PROPOSED CHANGE

PRESSURE-TEMPERATURE RELATIONSHIP

PROVISIONAL OPERATING LICENSE DPR-16
OYSTER CREEK NUCLEAR GENERATING STATION
GPU NUCLEAR CORPORATION
DOCKET NO. 50-219

3.3 REACTOR COOLANT

FIGURE 3.3.1
OYSTER CREEK P/T LIMITS

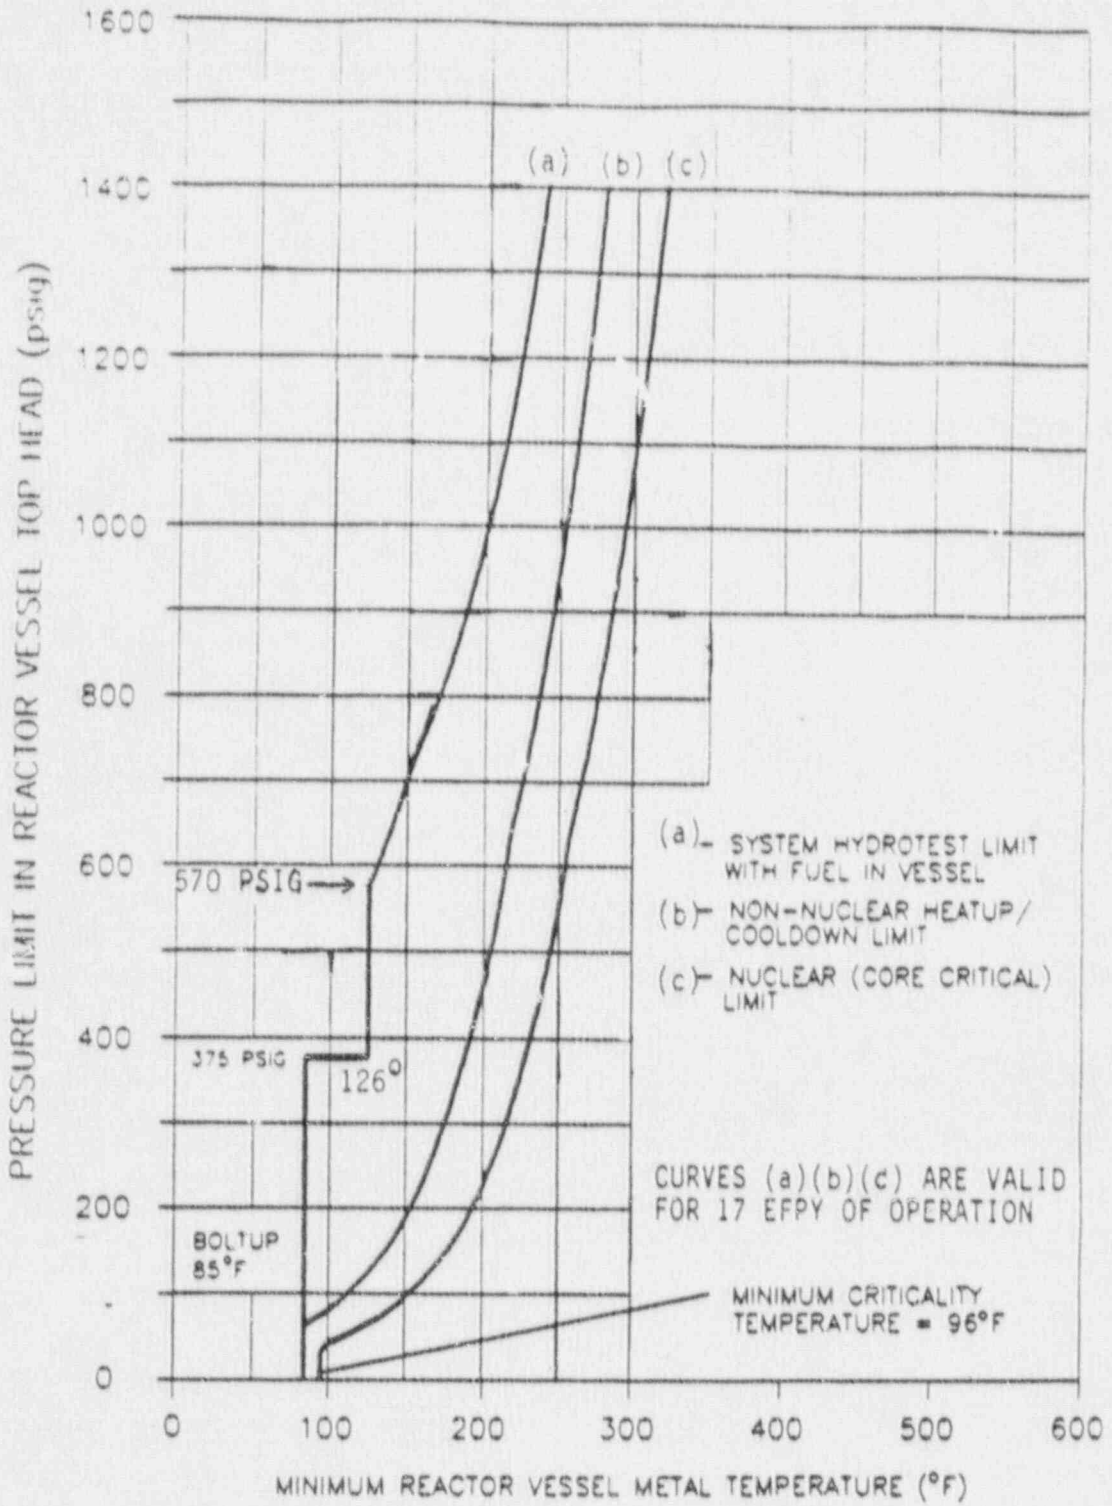
- (i) Reactor Vessel Pressure Tests - the minimum reactor vessel temperature at a given pressure shall be in excess of that indicated by the curve (a) in Figure 3.3.1. The maximum temperature for Reactor Vessel Pressure Testing is 250°F.
- (ii) Heatup and Cooldown Operations: Reactor noncritical -- the minimum reactor vessel temperature for heatup and cooldown operations at a given pressure when the reactor is not critical shall be in excess of that indicated by the curve (b) in Figure 3.3.1.
- (iii) Power operations -- the minimum reactor vessel temperature for power operations at a given pressure shall be in excess of that indicated by the curve (c) in Figure 3.3.1.

Note: Curves (a), (b) and (c) in Figure 3.3.1 apply when the closure head is on the reactor vessel and studs are fully tensioned.

- (iv) Appropriate new pressure temperature limits must be approved as part of this Technical Specification when the reactor system has reached seventeen (17) effective full power years of reactor operation.

Curves (a), (b) and (c) on Figure 3.3.1 are derived from an evaluation of the fracture toughness properties performed on the specimens contained in Reactor Vessel Materials Surveillance Program Capsule No. 2 (Reference 14). The results of dosimeter wire analyses (Reference 14) indicated that the neutron fluence ($E > 1.0$ MeV) at the end of 17 effective full power years of operation is 2.44×10^{18} n/cm² at the 1/4T (T=vessel wall thickness) location. This value was used in the calculation of the adjusted reference nil-ductility temperature which, in turn, was used to generate the pressure-temperature curves (a), (b), and (c) on Figure 3.3.1 (Reference 15). The 250°F maximum pressure test temperature provides ample margin against violation of the minimum required temperature. Secondary containment is not jeopardized by a steam leak during pressure testing, and the Standby Gas Treatment system is adequate to prevent unfiltered release to the stack.
